<b>Office Action Summary</b>	Application No.	Applicant(s)	
	10/814,797	HWANG, JI SICK	
	Examiner	Art Unit	
	Timothy M. Ayres	3637

This is a first office action on the merits of application SN 10/814,797.

Solak '874 Figures 1 and 2

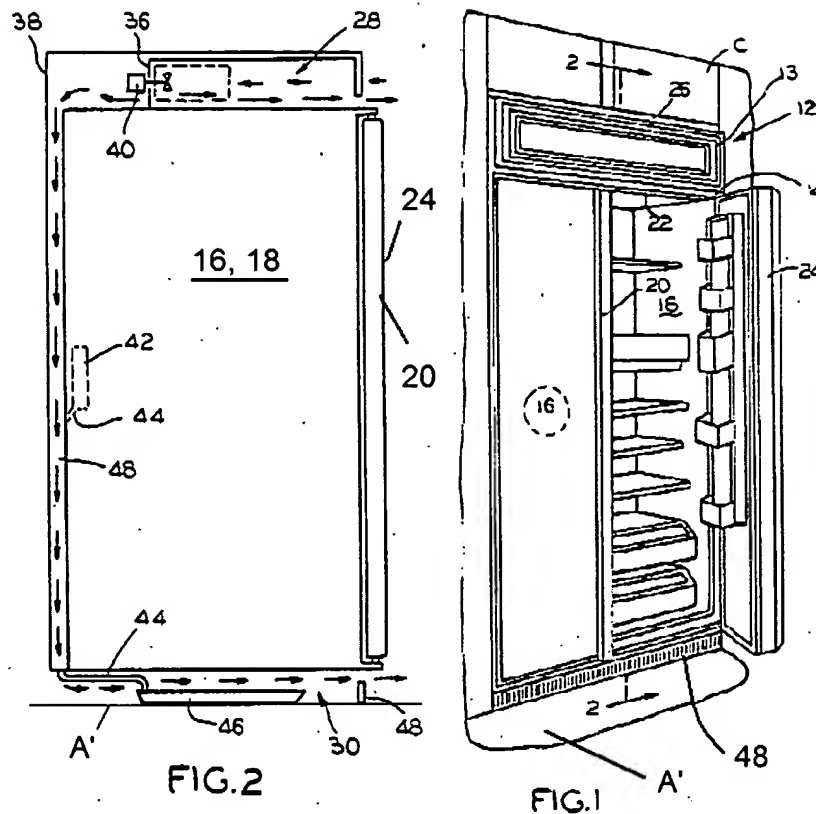
17. Claims 1 and 2 are rejected under 35 U.S.C. 102(b) as being anticipated by US Patent 4,970,874 to Solak. A built in refrigerator in parallel to an adjacent structure (A') comprises a housing (38) internally defining a space (16,18) and a door (20,24) hingebaly coupled to the housing to open and close the space. The center of hinging movement (axis of rotation) of the door is positioned outside of the housing as seen in figure 2. The refrigerator further comprises a spacing member (48), which defines a constant gap between the housing and the adjacent structure (A').
